ARCHITECHNICS, INC.
510 MAINE STREET
QUINCY, ILLINOIS 62301

ADDENDUM NO.: 1

ISSUED: 7/28/2023

Project: Phase II Renovations for:
The Knowledge Center - Chaddock
205 S. 24th Street
Quincy, IL 62301

DRAWN	CHECKED
DATE	DATE
DRAWING NAME	DRAWING NAME
PROJECT NO.	PROJECT NO.
23-0062	23-0062
SHEET NO.	SHEET NO.
C100	C100

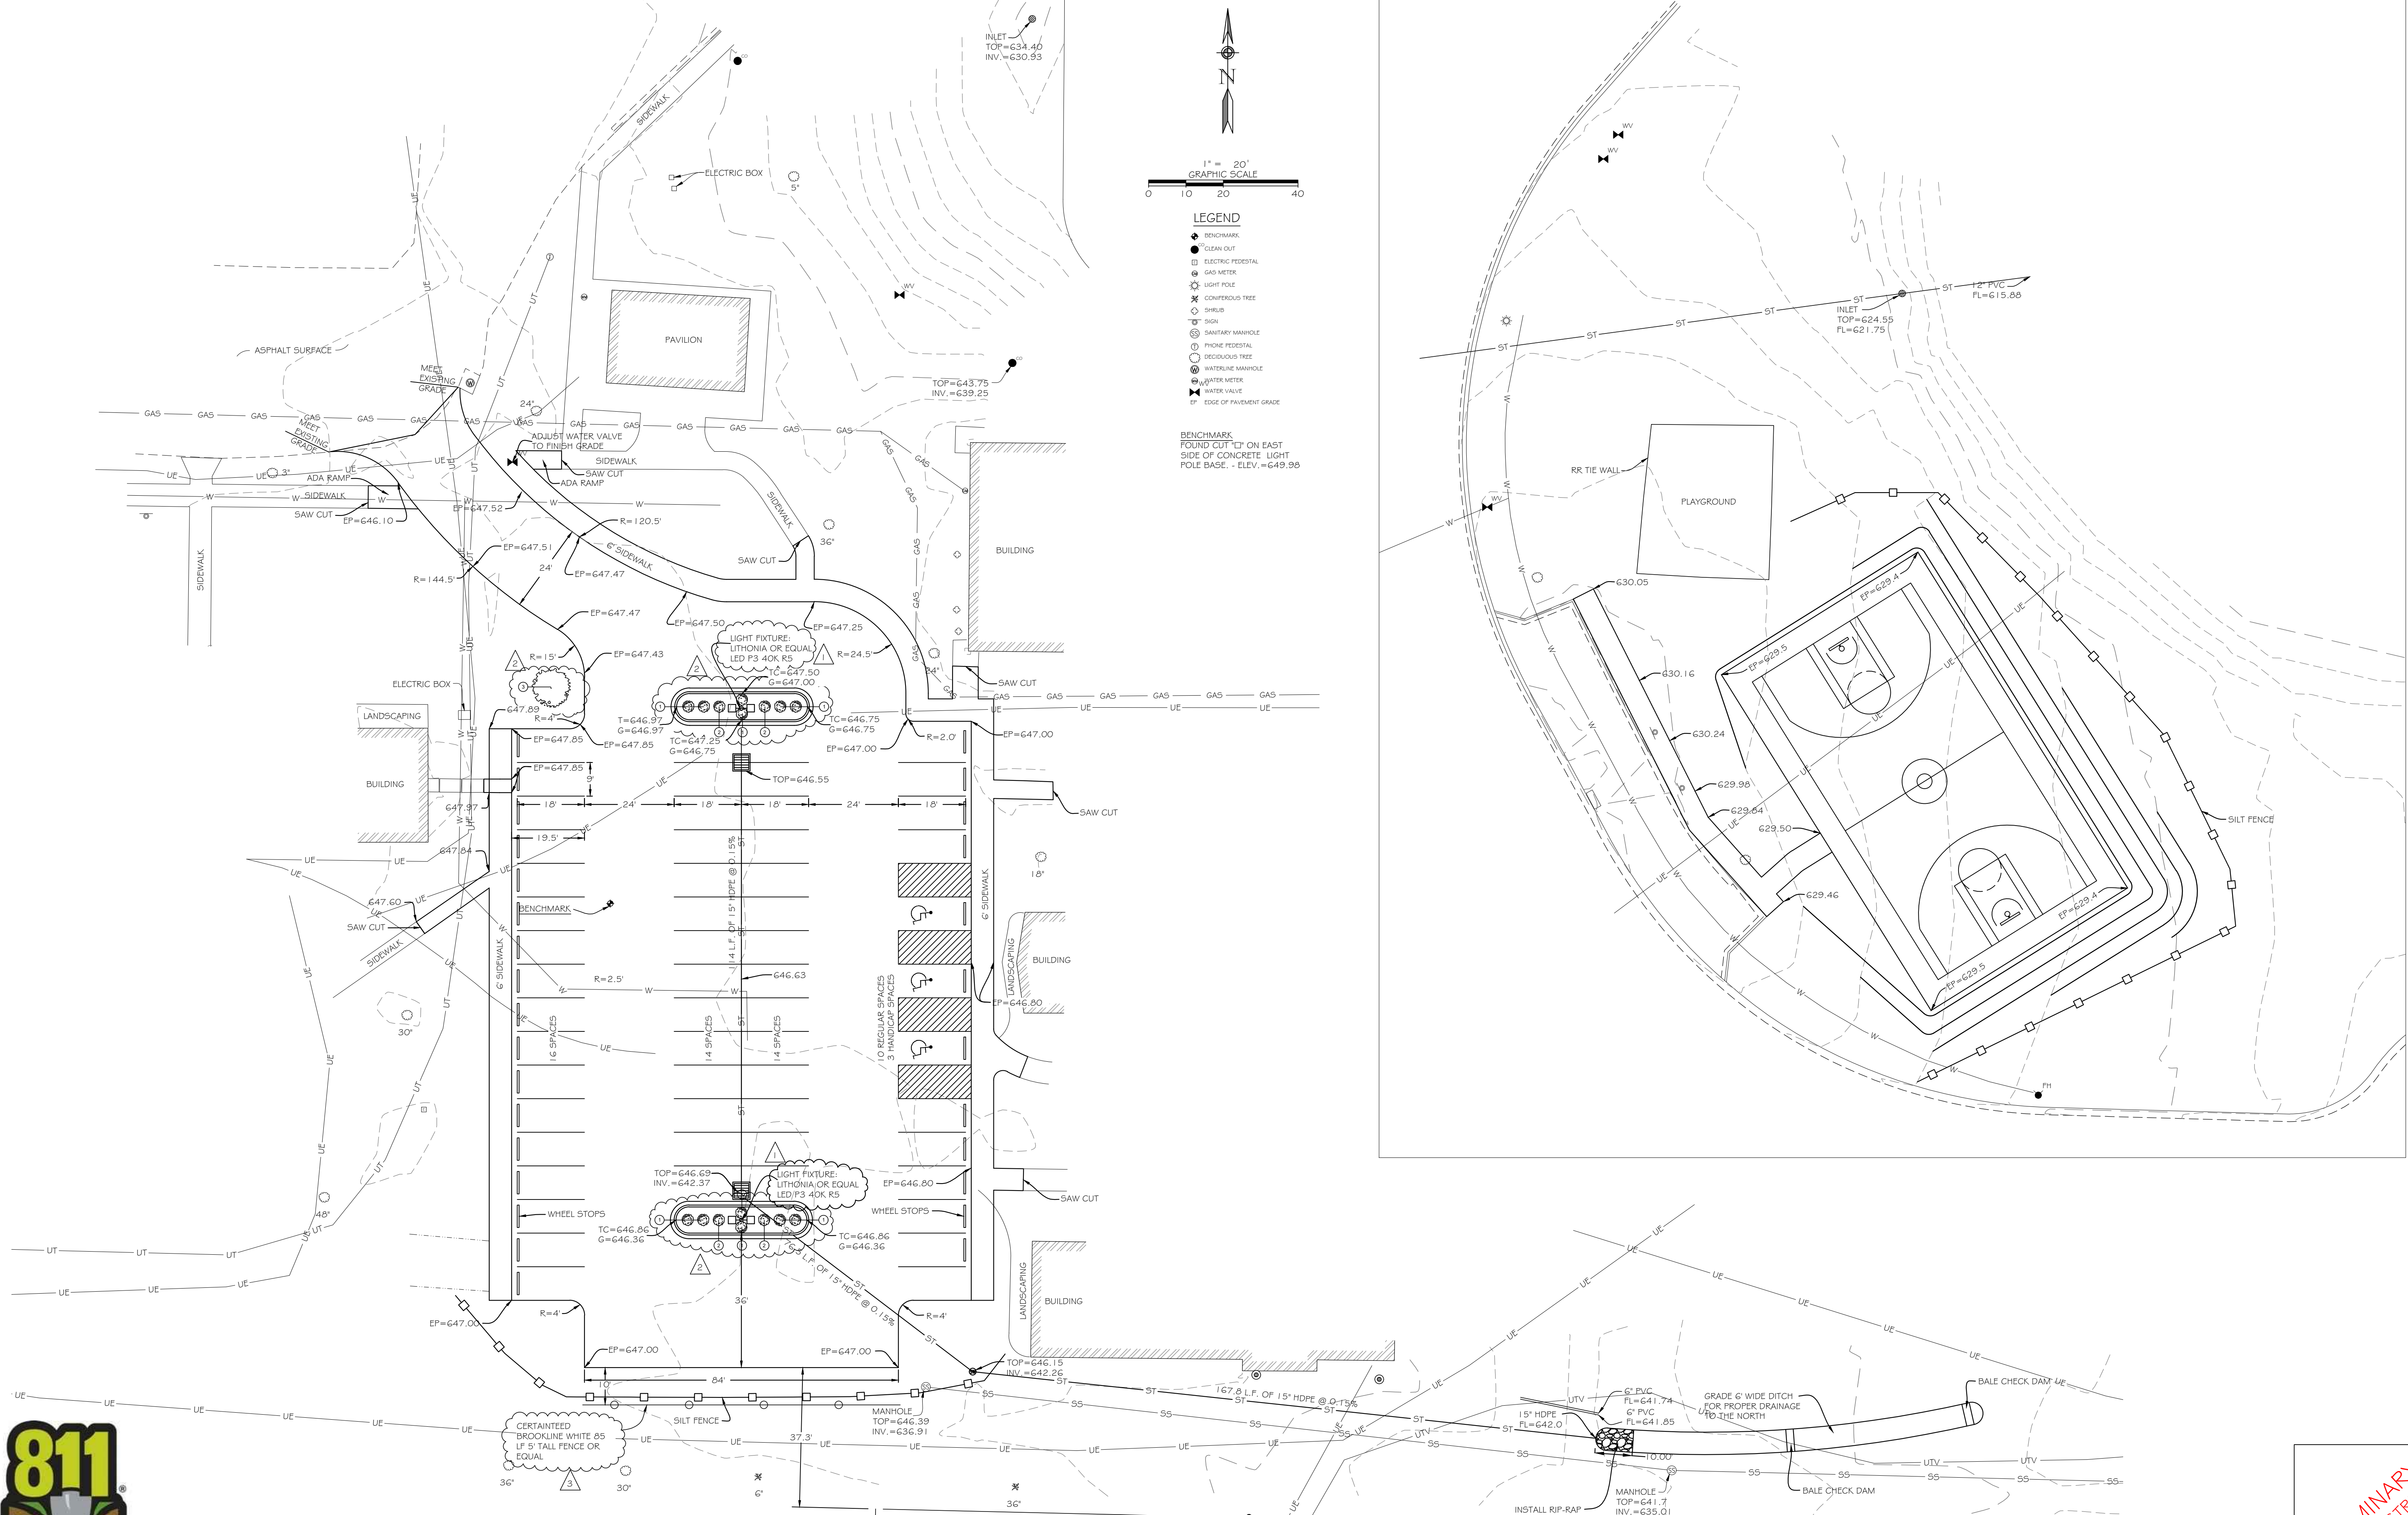
ITEM	DESCRIPTION
<u>Clarify</u>	
1.0 Site Plan	Asphalt paving is the base bid material for the new lot. Concrete paving is the alternate bid material (Alternate Bid A-4).
<u>Specifications</u>
